BRIGGS VILLAGE MASTER PLAN

ENVIRONMENTAL IMPACT STATEMENT

SUBJECT: Briggs Village Master Plan Final Environmental Impact Statement

FIGURE 2-1a.
EXISTING TOPOGRAPHY
BRIGGS URBAN VILLAGE MASTER PLAN EIS
OLYMPIA, WASHINGTON

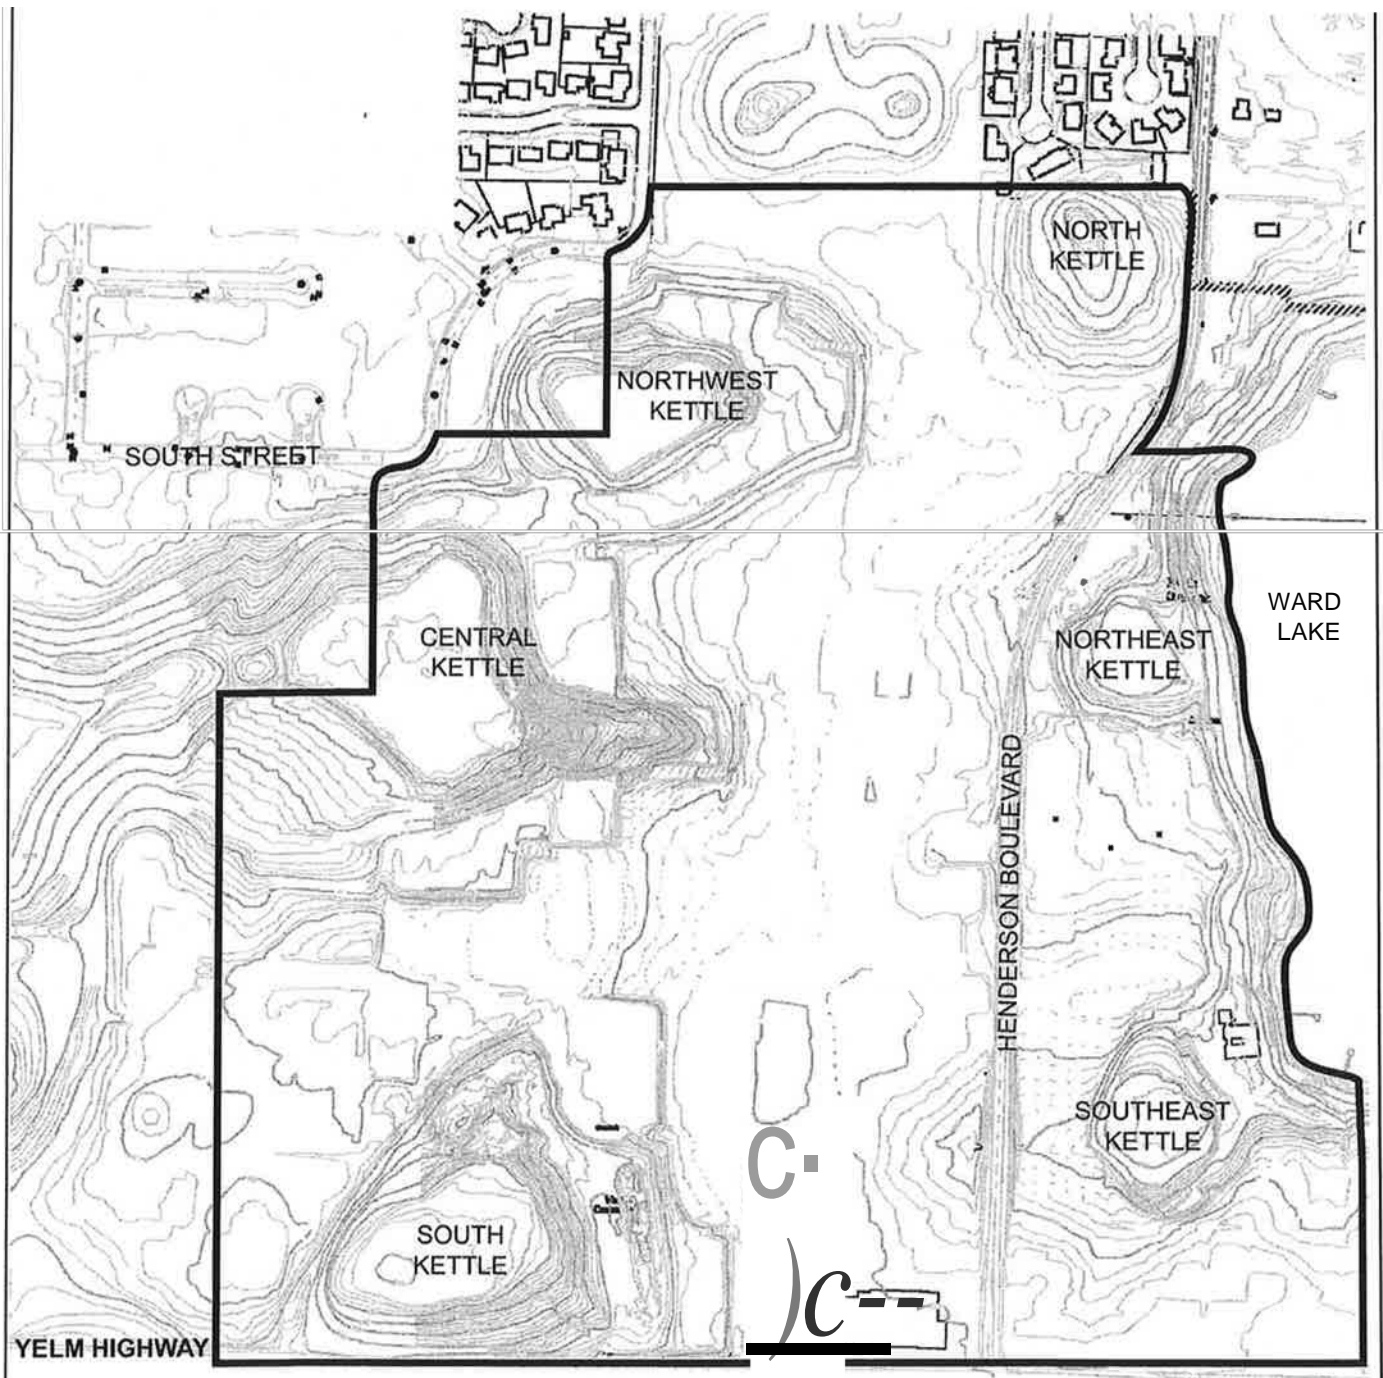
Page 2-23: Kettles. The figure numbers throughout this section are incorrect. Figure 2-2 is the soils map and does not show the kettles. Figure 2-1a is probably the correct figure. Also on this figure and others the Northwest Kettle is mistakenly identified as the West Kettle.

FIGURE 2-2.
THURSTON COUNTY SOIL SURVEY
BRIGGS VILLAGE MASTER PLAN EIS
OLYMPIA, WASHINGTON

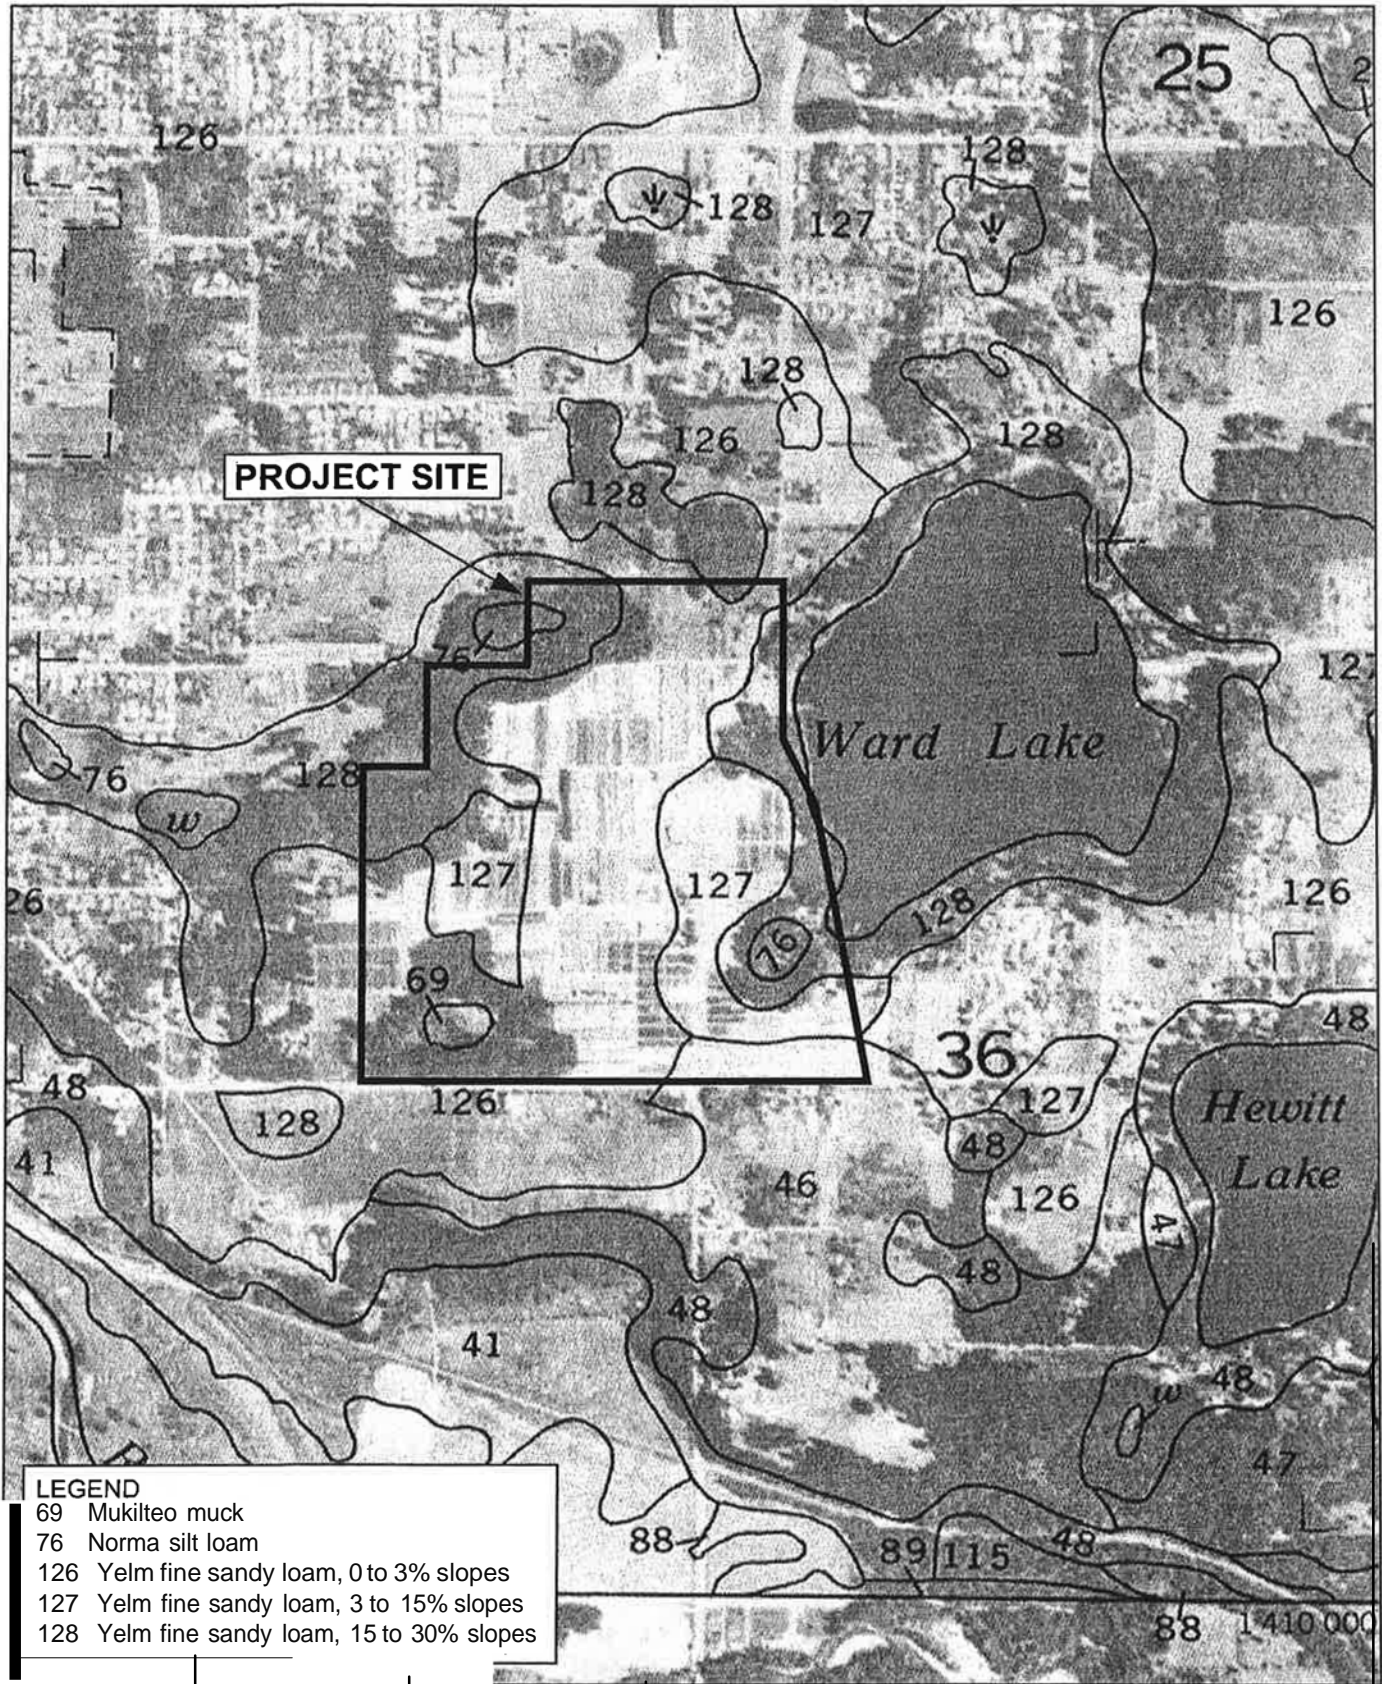
Page 2-10: Figure 2-2. Thurston County Soil Survey Briggs Village Master Plan EIS. Soil Type 126 is not included in the figure legend. This soil constitutes the majority of the site. From the write-up it appears that it should be Yelm fine sandy loam on slopes of less than 3 percent. I would like to see another map that shows areas of fill and other disturbed soil since it is clear from the history of the site that the natural topography has been disturbed by nursery operations.

10. Kautsky, Chris
 - A. Soil Type 126 has been added to the Figure 2-2 legend. There is a figure titled "Briggs Village Critical Areas" in the Master Plan Development Application that provides topography on the site. This figure shows steep slopes, cuts, and proposed slope buffers. This document is available for review at the City Planning office.
